Re: Enterprise/ Car Wash
5700 San Mateo Blvd. NE
Traffic Circulation Layout
Architect's Stamp 03-22-22 (F18-D052)

Based upon the information provided in your submittal received 3-30-22, the above referenced plan cannot be approved for Building Permit until the following comments are addressed:

SITE - TCL PLAN

DRAWING TITLE		
SITE PLAN - TCL		
	DESIGNED	PROJECT NO
	DRAWN	SCALE
	CHECKED	DRAWING NO
	REVIEWED	A-100
	DATE 03/22/2022

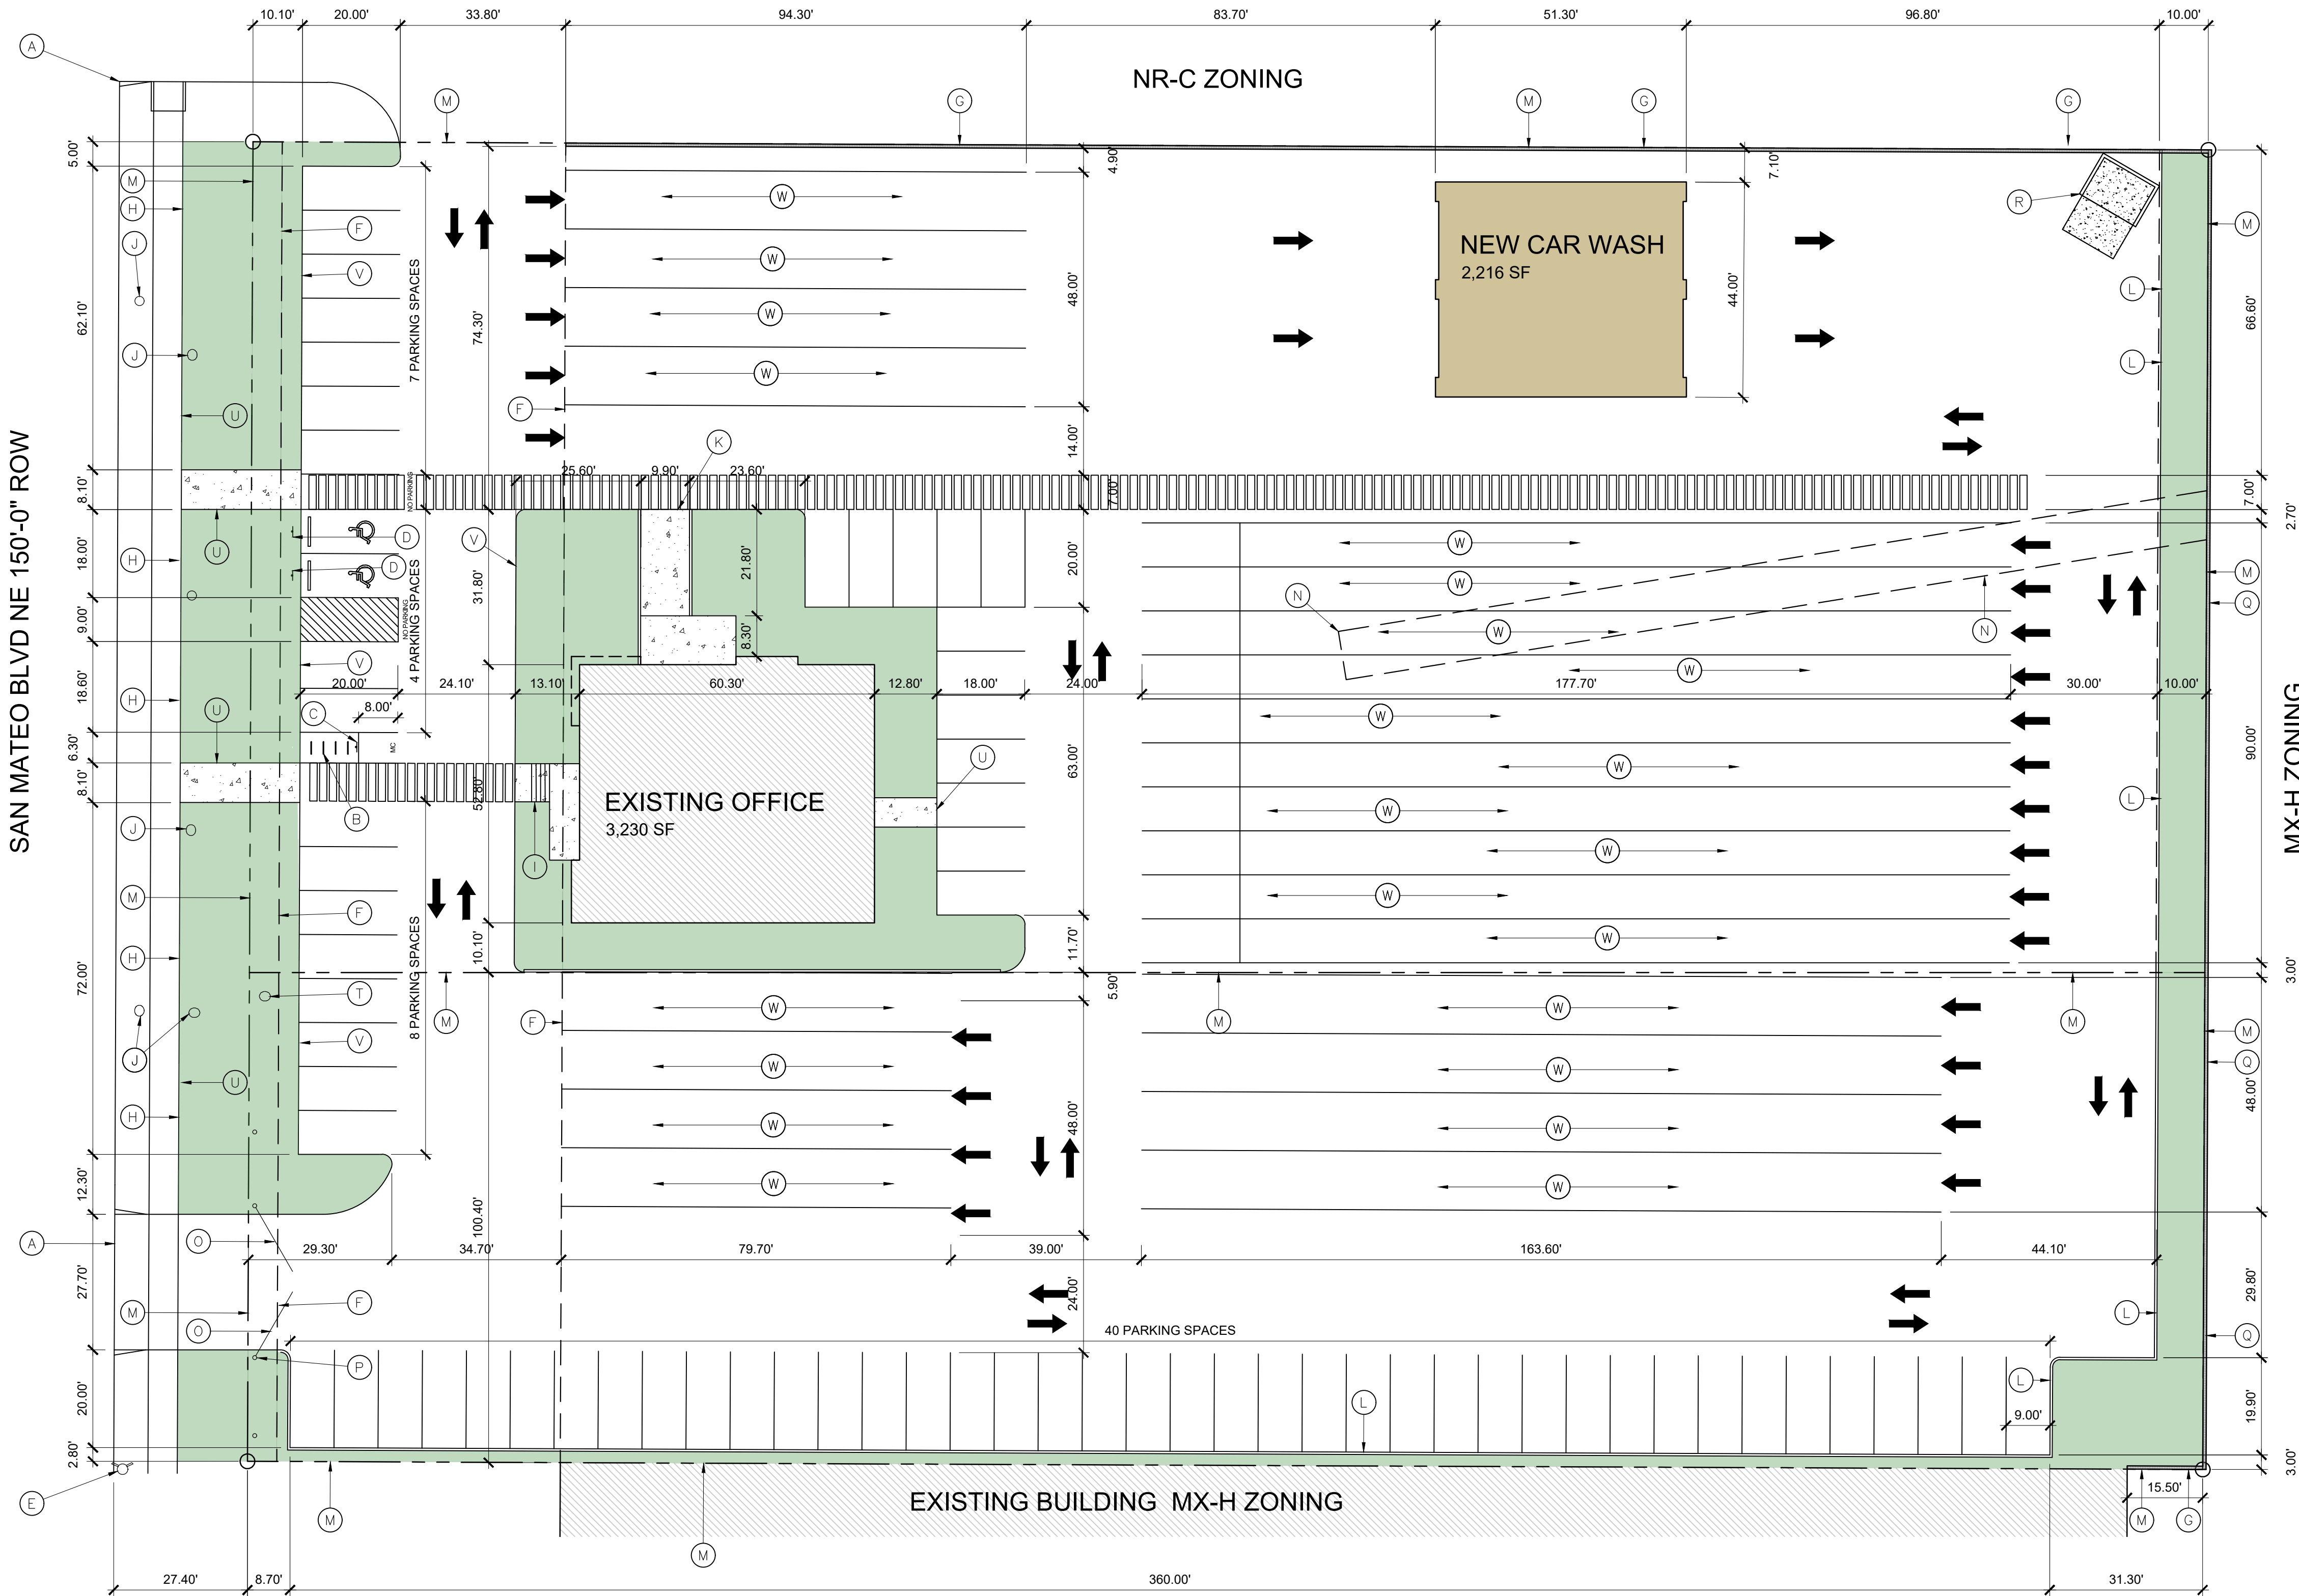
1. Driveways entrances off San Mateo Blvd. need to be updated to current ADA std. or Curb Return is recommended on Principal Arterial. San Mateo classified as Principal Arterial.
2. Maximum access width for arterial, collector, and local streets are as follows:

3. Key note K: provide details for the existing ADA ramp (dimensions, running slope, and a cross slope).
4. Per IDO Required Stacking space, you need to show minimum 3 vehicles stacking spaces in the car wash lanes.
5. Please list the width and length for all existing and proposed parking spaces. Some dimensions are not shown.
6. The minimum parking stall dimensions are:

9. The 14' width lane between the car wash and the pedestrian pathway must be One Way.
10. All one-way drives shall have "One Way" and "Do Not Enter" signage and pavement markings. Please show detail and location of posted signs and striping.

11. Per DPM, a 6 ft. wide ADA accessible pedestrian pathway is required from each ADA parking stall access aisles to the building entrances. Please clearly show this pathway and provide details.

12. ADA accessible pedestrian pathway should not be placed behind parking space or adjacent to a vehicular way. Vehicle and pedestrian/wheel chair conflicts should be avoided as much as possible.

13. Key note W: please verify the purpose of this area, and provide proper signages to prevent cars turning into places where they shouldn't by accident

14. Curbing should be installed to delineate landscape, parking, and pedestrian ways and identify points of access. Please call out detail and location of barrier curb.

15. Parking areas shall have barriers to prevent vehicles from extending over public sidewalk, public right-of-way, or abutting lots.
16. Refuse vehicle maneuvering shall be contained on-site. The refuse vehicle shall not back into the public right of way.; provide a copy of refuse approval.

17. Provide a copy of Fire Marshal Approval.
18. It is not apparent what type of pavement surface is being proposed. A hard driving surface will be required as part of this proposed project for parking area and drive aisles.

19. Please provide a sight distance exhibit
20. Show the Intersection Sight Distance triangle and add the following note to the plan: "Landscaping and signage will not interfere with clear sight requirements. Therefore, signs, walls, trees, and shrubbery between 3 and 8 feet tall (as measured from the gutter pan) will not be acceptable in the clear sight triangle.
